COLCHESTER BOROUGH COUNCIL

Response to ECC Consultation on proposed Cycle Safety Schemes

Report of	Assistant Director Policy and Corporate	Author	Jane Thompson
Title	Response to ECC Consultation on proposed Cycle Safety Schemes		
Wards affected	Greenstead and Lexden and Braiswick

GREENSTEAD ROAD & HYTHE STATION ROAD, COLCHESTER (CASUALTY REDUCTION '18/19)
 LCOL 181003

Appendix 1

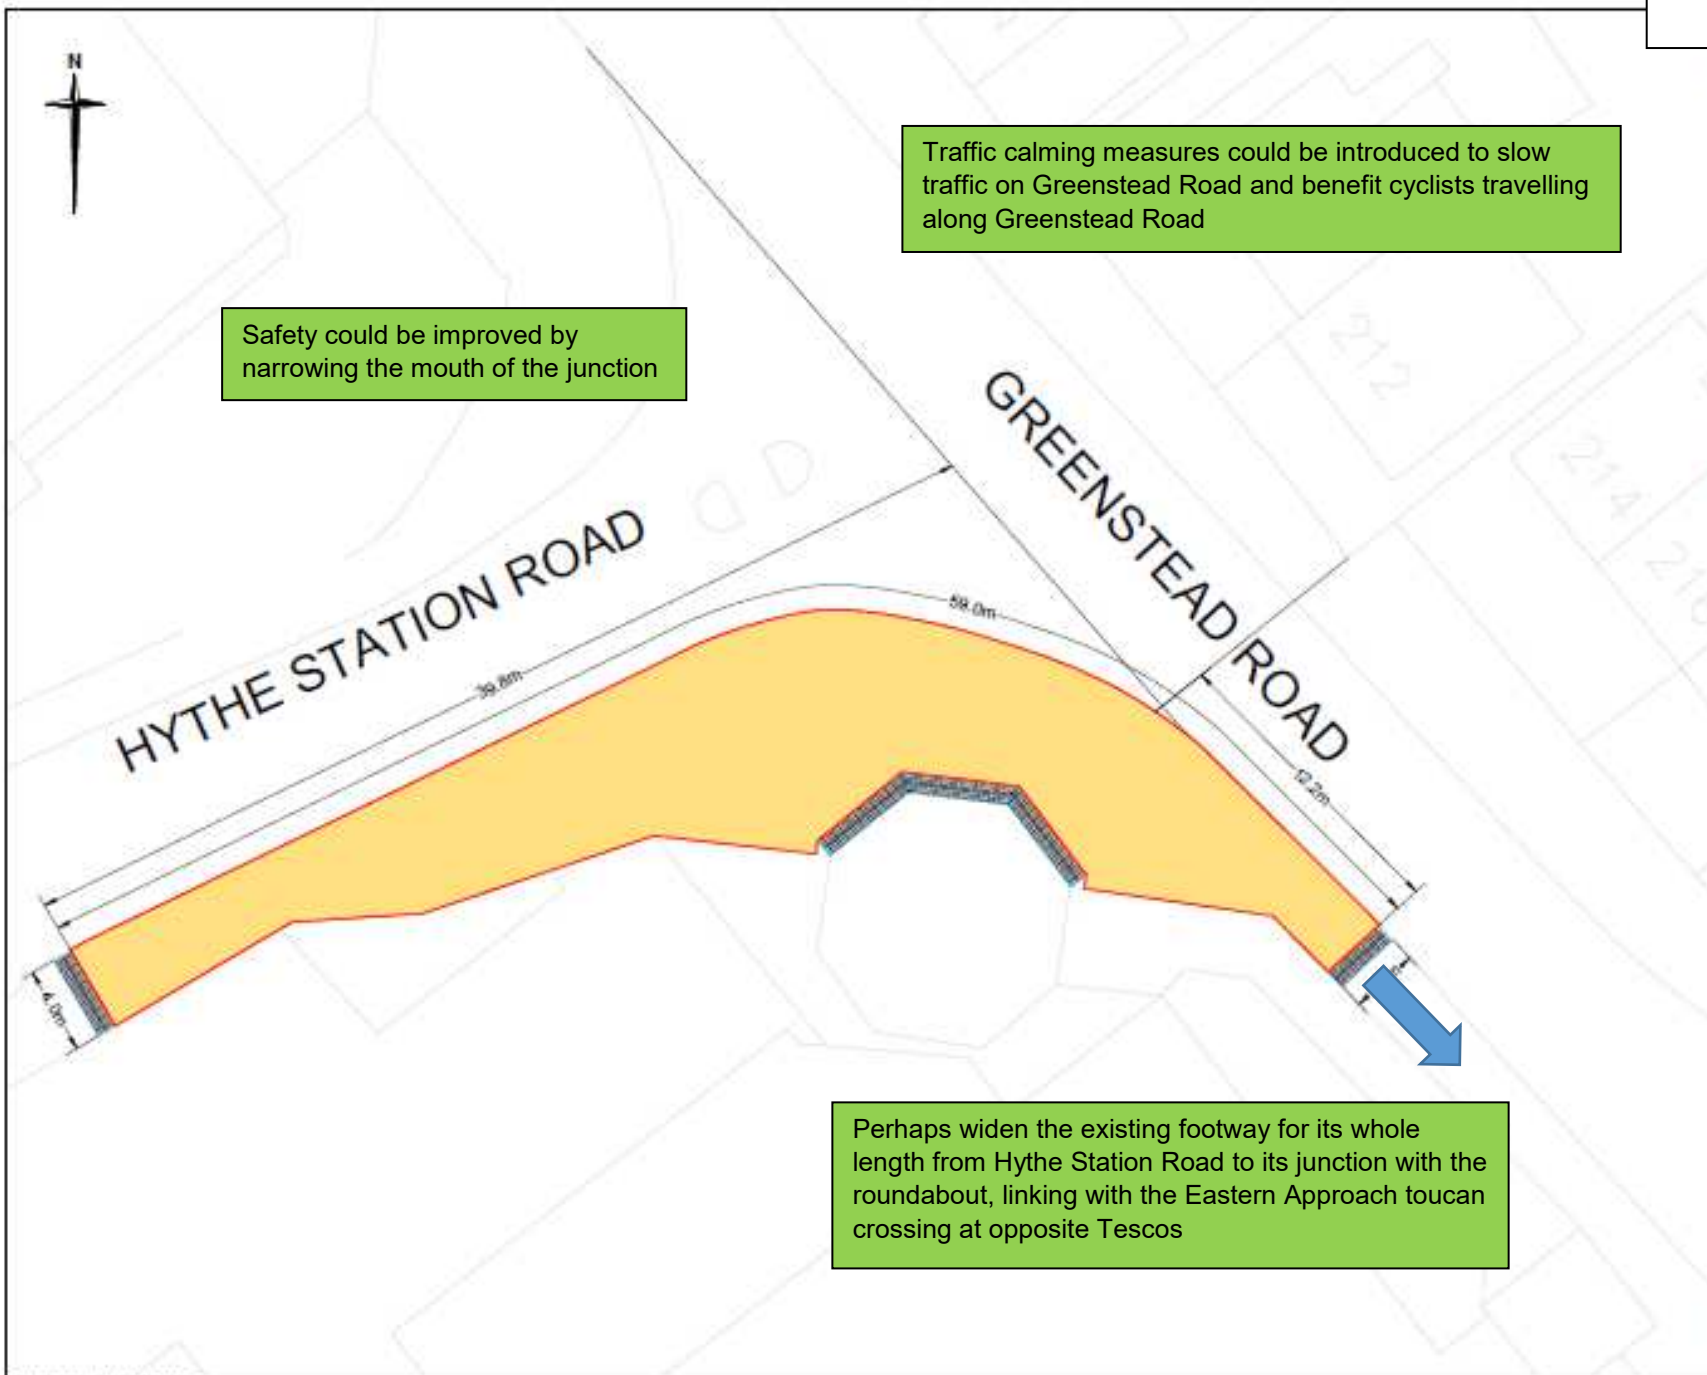
5.6 This proposal is to convert a short section of footway to a shared unsegregated footway/cycleway on the south and west side junction of Greenstead Road and Hythe Station Road. This scheme does not benefit cyclists traveling northbound and southbound on Greenstead Road. The new cycle paths will not connect to existing cycle paths and do little to add to a 'connected network' in the area.

5.7 The plans do not show how a cyclist will access the short section of shared use path, and if cyclists are encouraged to cross oncoming traffic to access the path, then this is likely to increase their risk of collision. The benefits are not clearly expressed.

5.8 It is considered that it may be better to widen the existing footway where necessary from Greenstead Road's junction with the Greenstead Road roundabout for its whole length on the western side, to its junction with Hythe Station Road. This route is shown in the Colchester Cycling Action Plan. This is a busy route used by cyclists accessing the Wivenhoe Trail from the University as well Hythe Station. This will mean only one carriageway will need to be crossed and this will be the relatively quiet Hythe Station Road. A plan showing these suggestions can be found as Appendix 1.

Traffic calming measures could be introduced to slow traffic on Greenstead Road and benefit cyclists travelling along Greenstead Road

Safety could be improved by narrowing the mouth of the junction

Perhaps widen the existing footway for its whole length from Hythe Station Road to its junction with the roundabout, linking with the Eastern Approach toucan crossing at opposite Tesco's

Appendix 2

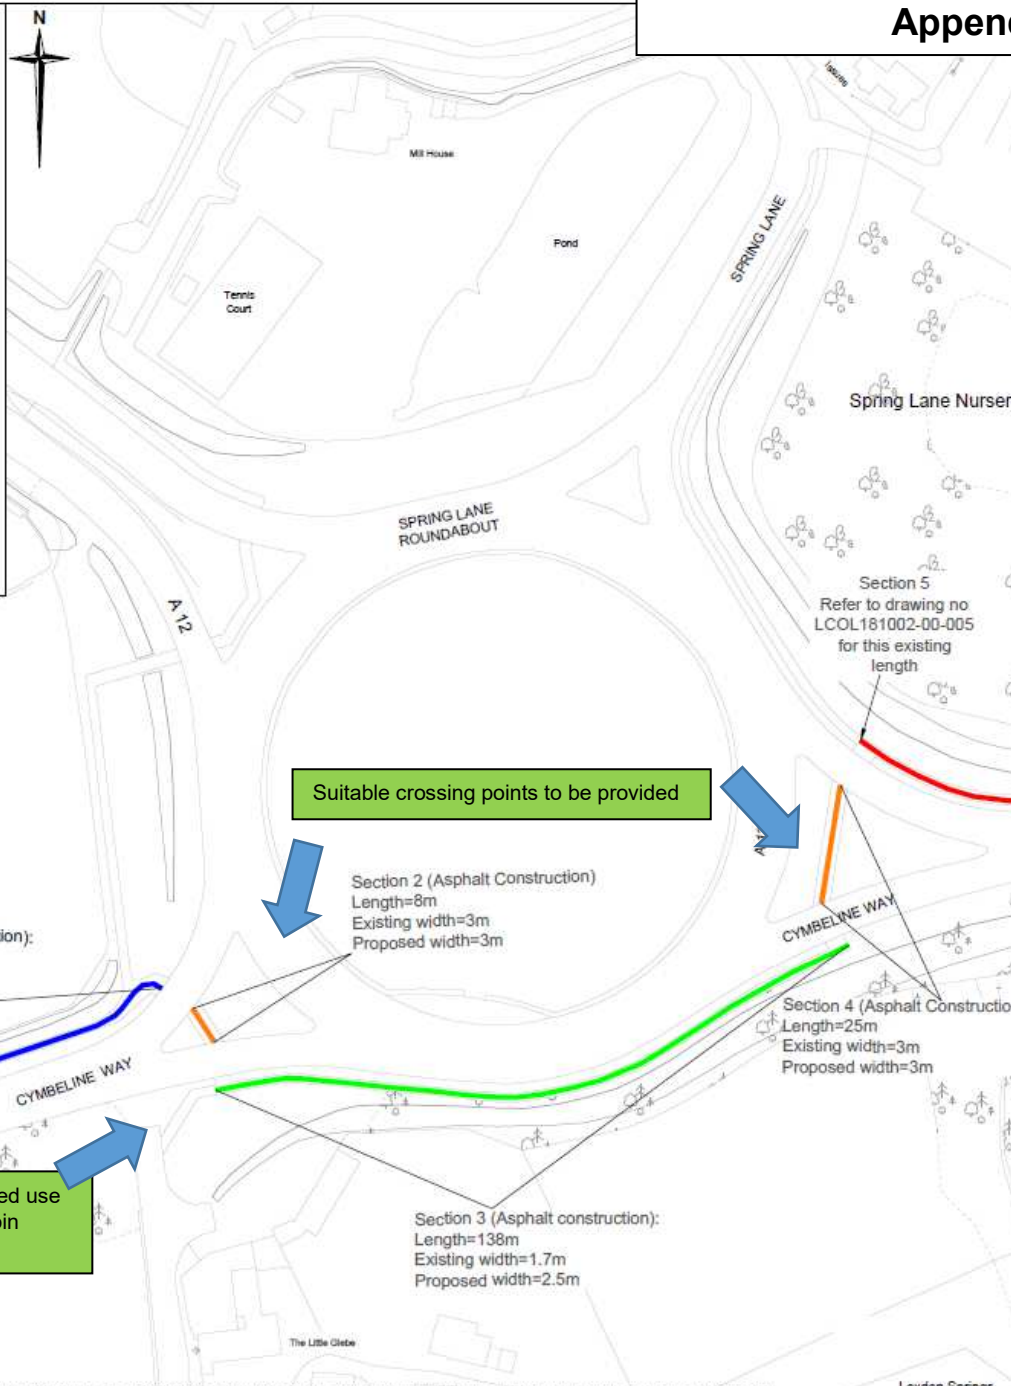
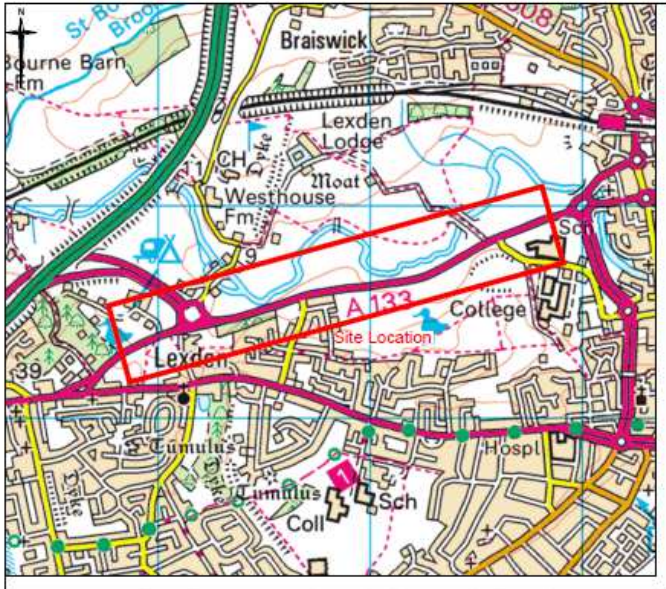
- 5.13 The proposals are set out below, with officer comments and are illustrated on the appended plan:
- Cymbeline Way east north side - this will formalise an existing use and no further work is proposed.

- Cymbeline Way to Spring Lane crossing points – consideration needs to be given on how safety can be improved for those crossing here due to high volume and high speeds of traffic at these points.

- Spring Lane roundabout southside - it is proposed to widen the existing path which runs from the Cymbeline Way crossing point to Spring Lane. In the proposal it is not proposed to link the path to Spring Lane. We propose that the path is extended westwards and southwards to link to this important access way to Lexden Road and Church Lane serving Prettygate west.

- Spring Lane to Cymbeline Way west crossing points – consideration needs to be given on how safety can be improved for those crossing here due to the high volume and high speeds of traffic at these points.

- Cymbeline Way west – it is proposed to widen this section of path which runs from the crossing points to the entrance to Maltings Farm. It is suggested that this route should be continued south westwards to join London Road. This route is listed in the Cycling Action Plan as a priority route linking Tollgate and Stanway to Colchester Station.

- 5.14 A plan showing these suggestions can be found as Appendix 2.
